# Groundwater Transfer Review Summary Form

Transfer/PA # T- 14768

Application: T-14768

Applicant Name: Desert Springs Ranch Limited Partnership

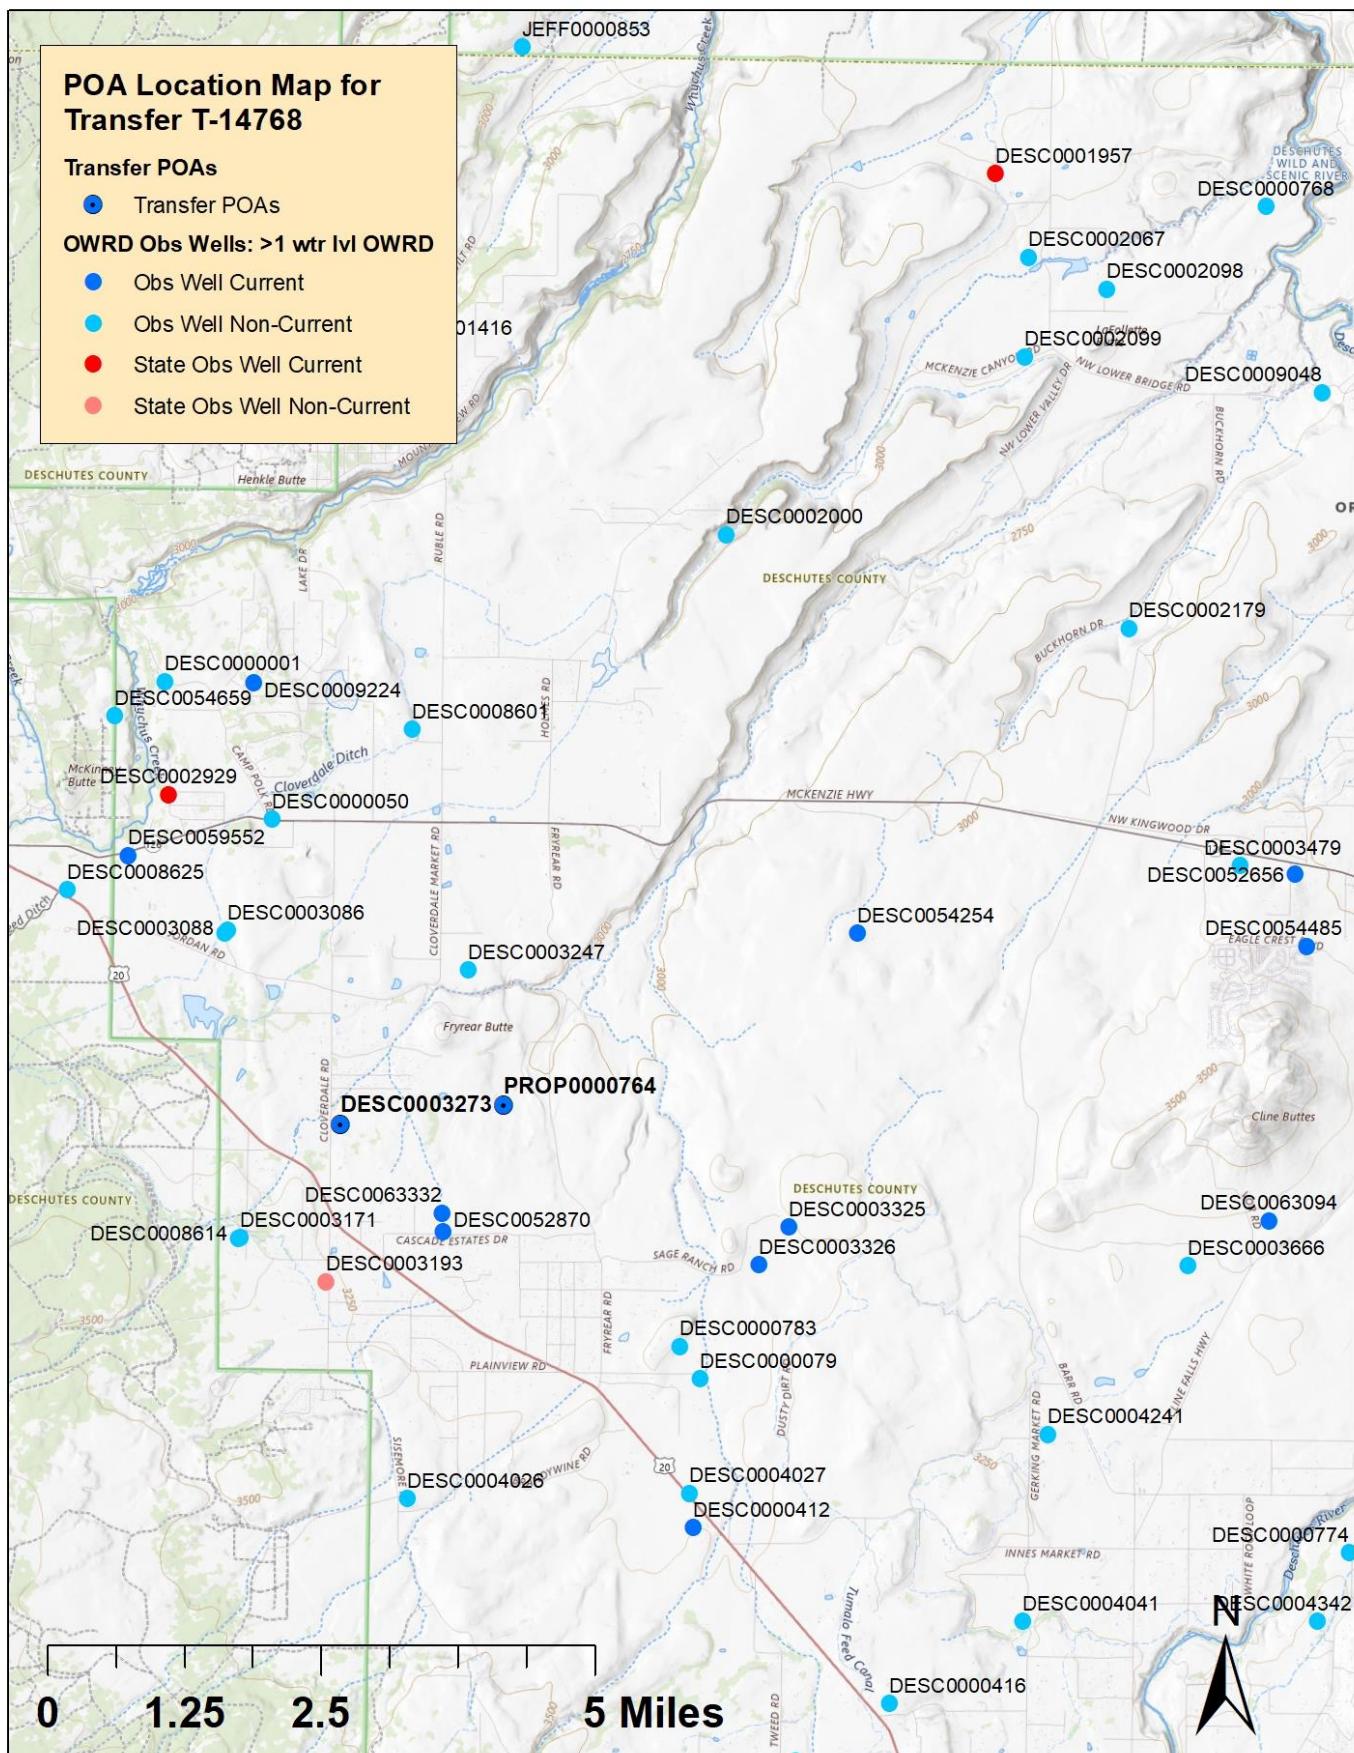
1. Basic description of the changes proposed in this transfer: Certificate 92958 authorizes 30.4 acres of irrigation from one well (DESC 3273) at a maximum rate of 0.38 cfs (170 gpm). This transfer proposes to add an APOA located approximately 1.5 miles to the east.

2. Will the proposed POA develop the same aquifer (source) as the existing authorized POA?  
 Yes     No    Comments: DESC 3273 was originally 240 feet deep and was deepened to 400 feet in 2023. This well accesses the Deschutes regional aquifer hosted within the mixed volcanics, volcanogenic sediments, and alluvium of the Deschutes Formation. The APOA (PROP 768 in GWIS) has a proposed depth of 400 feet. It is located 1.5 miles east of DESC 3273. It would also access the Deschutes regional aquifer hosted within similar lithologies of the Deschutes Formation.

Yes  No Comments: Adding an APOA will increase groundwater development in that area. The closest well to the APOA is DESC 3318 and is located 1680 feet to the north. The proposed changes may cause a low-magnitude increase in well-to-well interference.

Yes  No If yes, explain: Considering the aquifer's storage, permeability, and thickness, it is unlikely that any increase in well-to-well interference would result in drawdowns that would be considered substantial or undue interference.

Yes  No Comments: The closest point of groundwater-surface connection between the target aquifer and a stream is the Lower Bridge area, where the regional aquifer begins discharging to the Deschutes River and springs immediately adjacent to it. The APOA is located 10.4 miles and the original well is 11.6 miles from this area. Moving groundwater production closer to that GW-SW connection would cause a low-magnitude, short-term increase in interference. Assuming that this transfer would not increase groundwater use, there would be no long-term increase in stream depletion.

Provide context for minimal/significant impact: As discussed above, the proposed change would cause a low-magnitude, short-term shift in the timing of stream depletion impacts to the Deschutes River, but no overall change in that stream depletion.
